ADDENDUM #3

3 April 2026

RE: Maize USD 266 – Bus Storage Building

Project #: 5537.50

A42.1

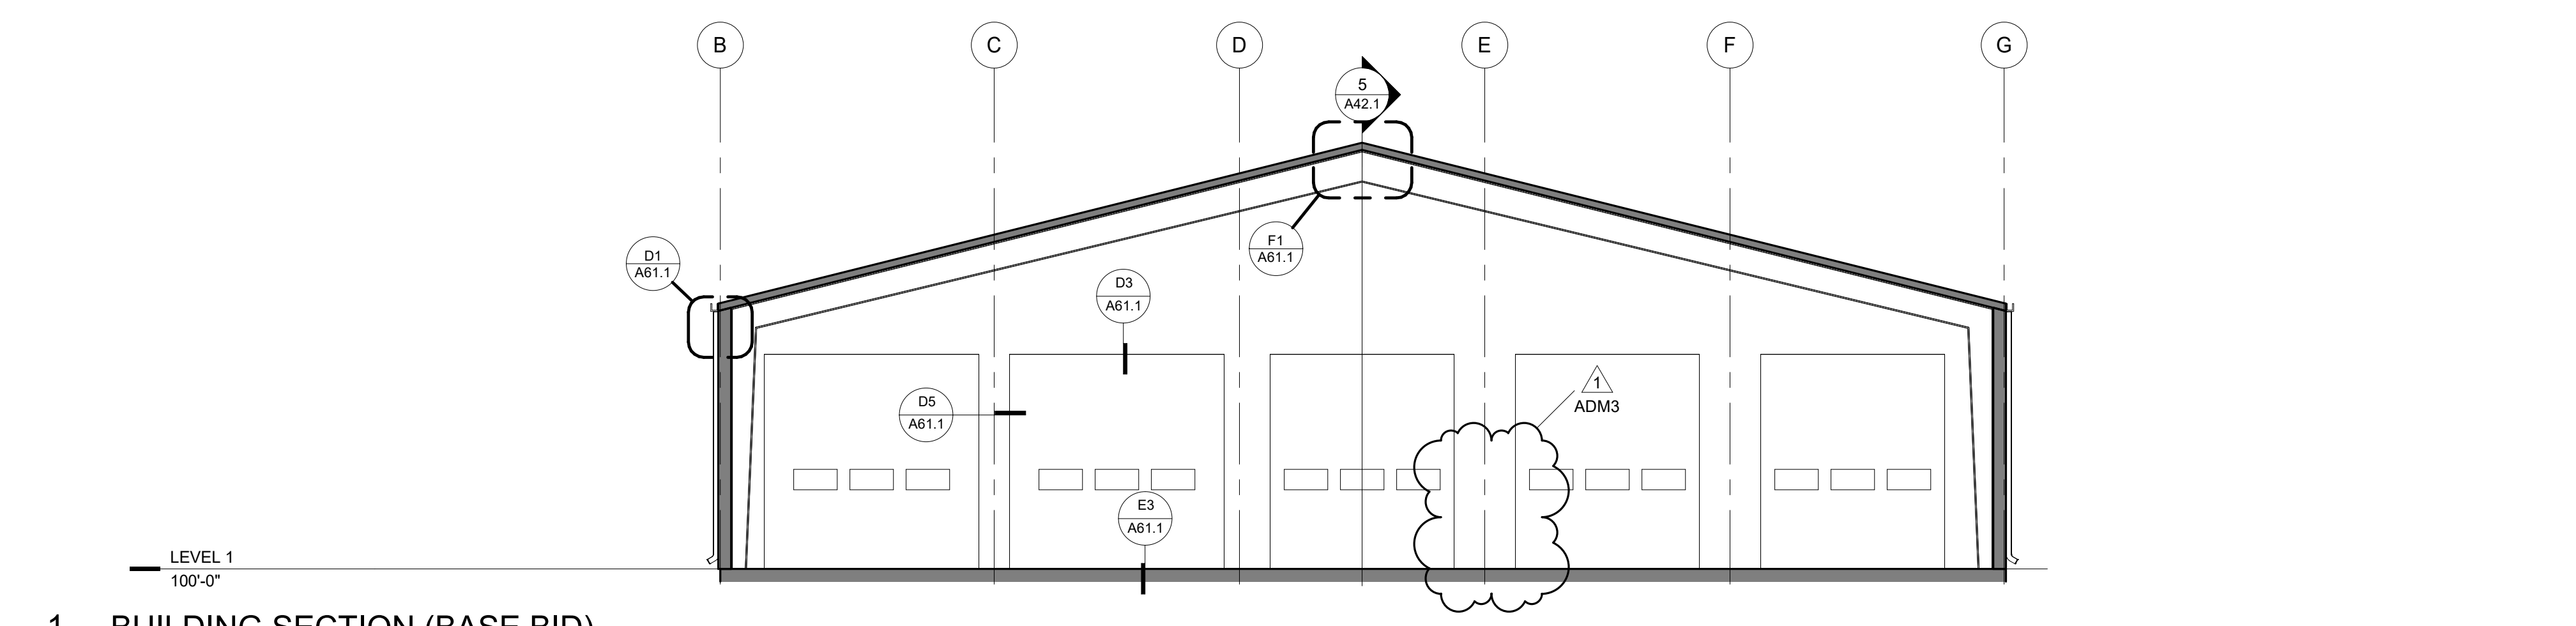
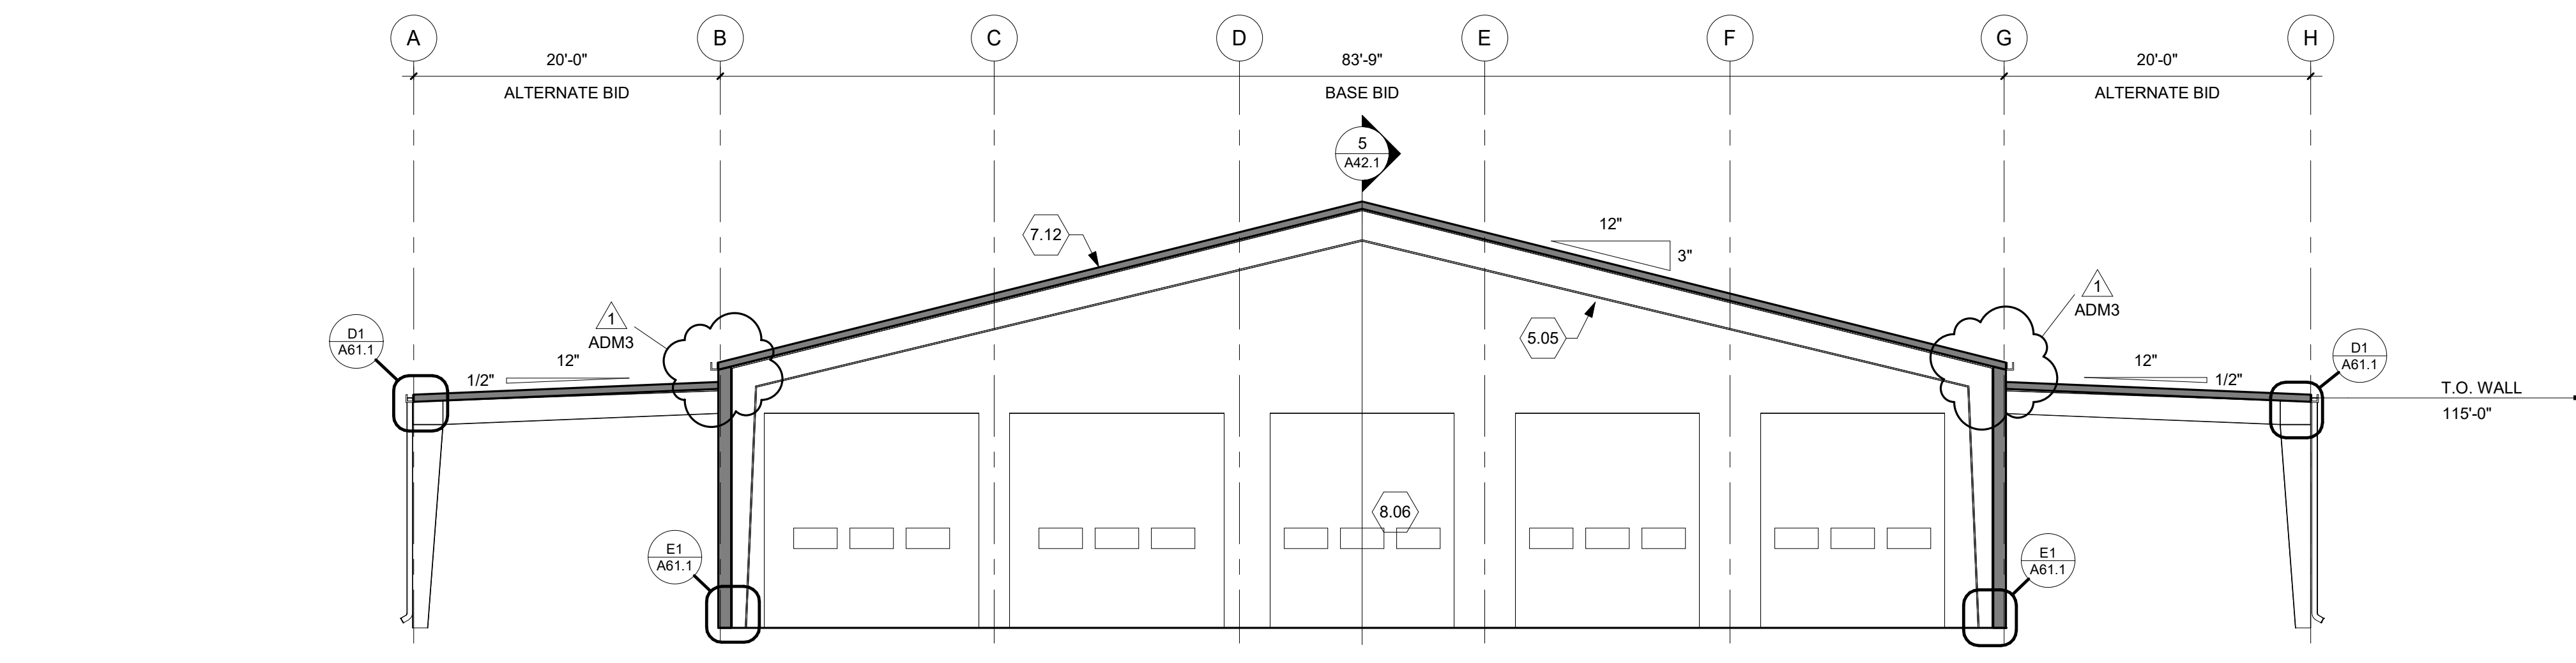
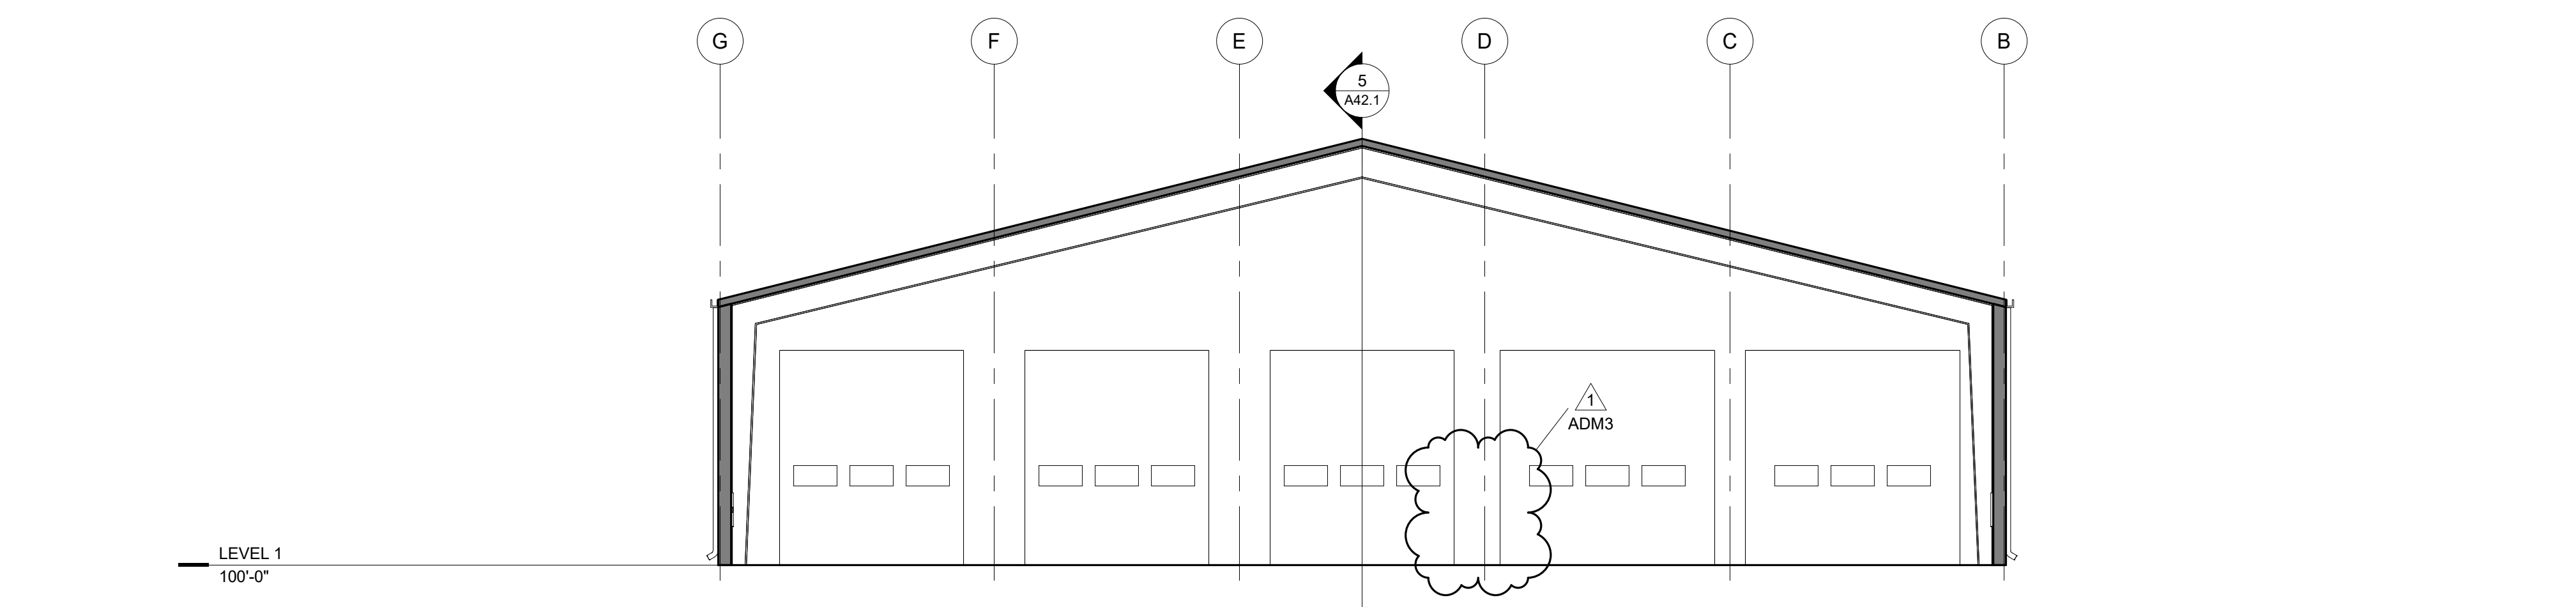
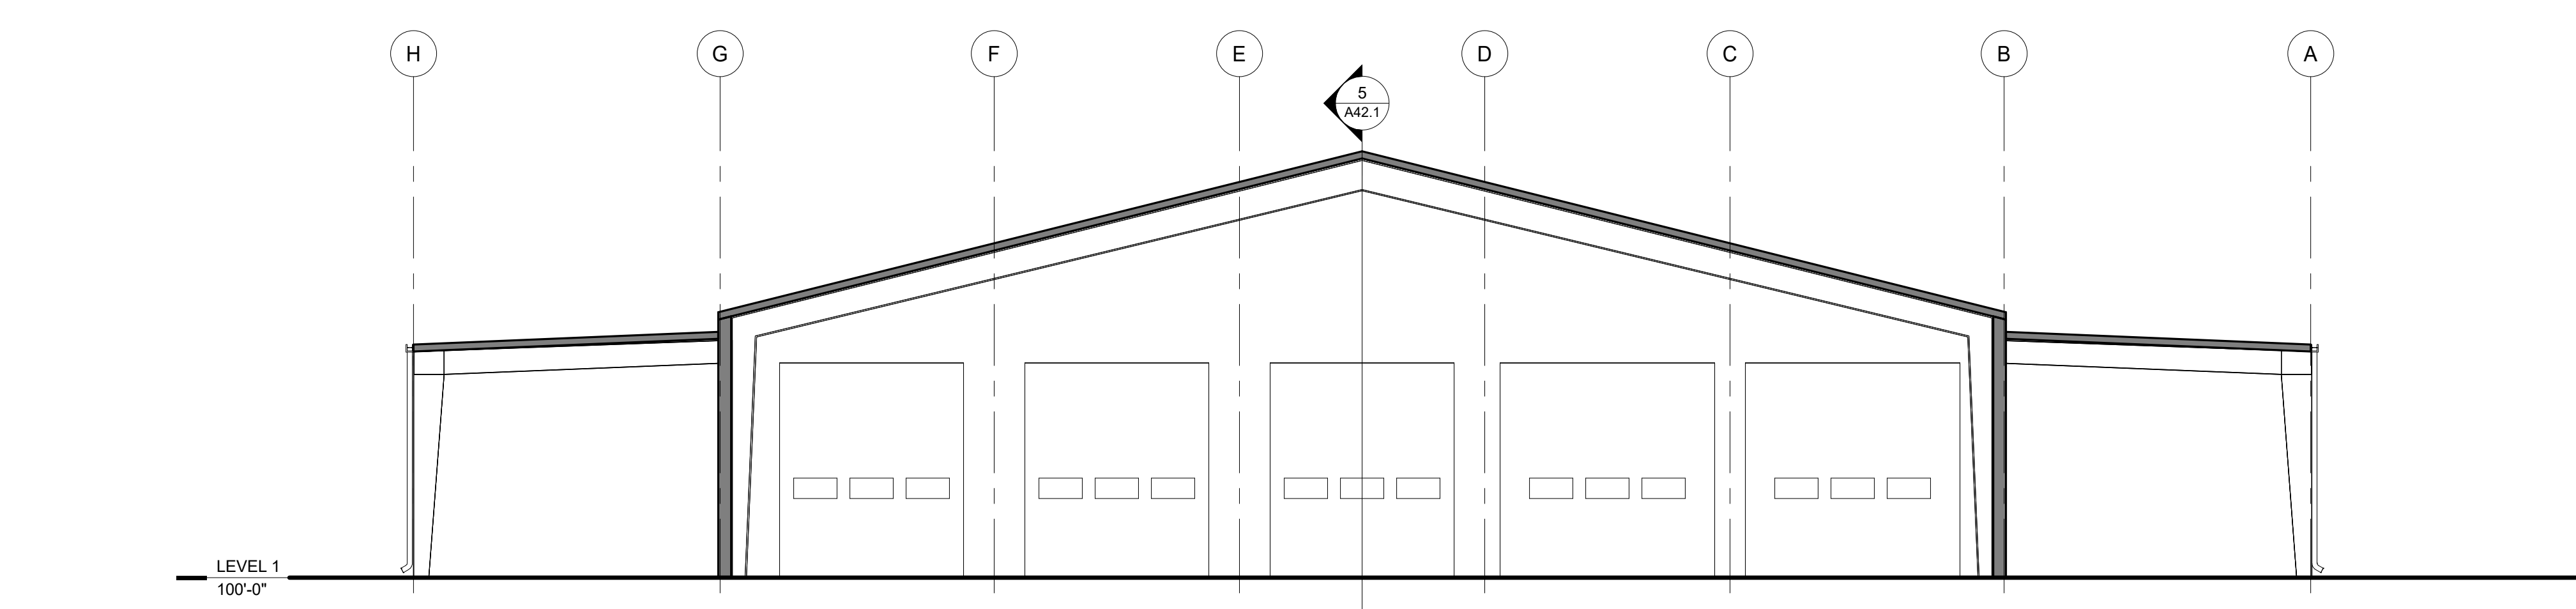
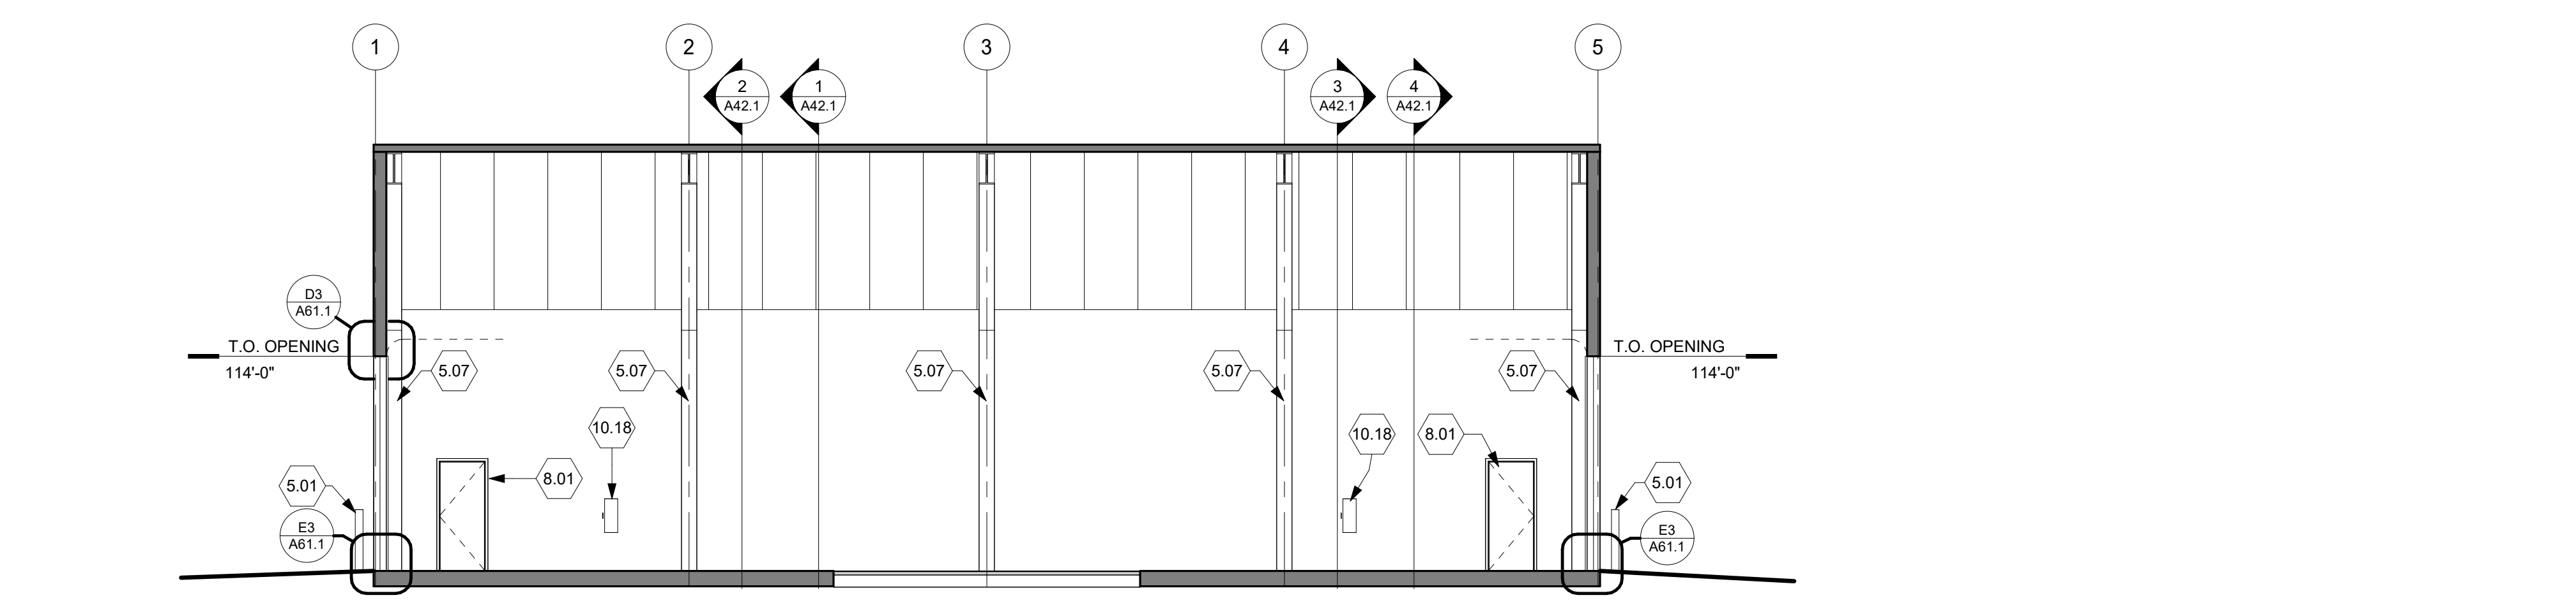
Item AD3-A07 Drawing Sheet A42.1 – Building Sections:

DELETION: Delete all the steel bollards on the interior of the building. Ref. attached Sheet A42.1.
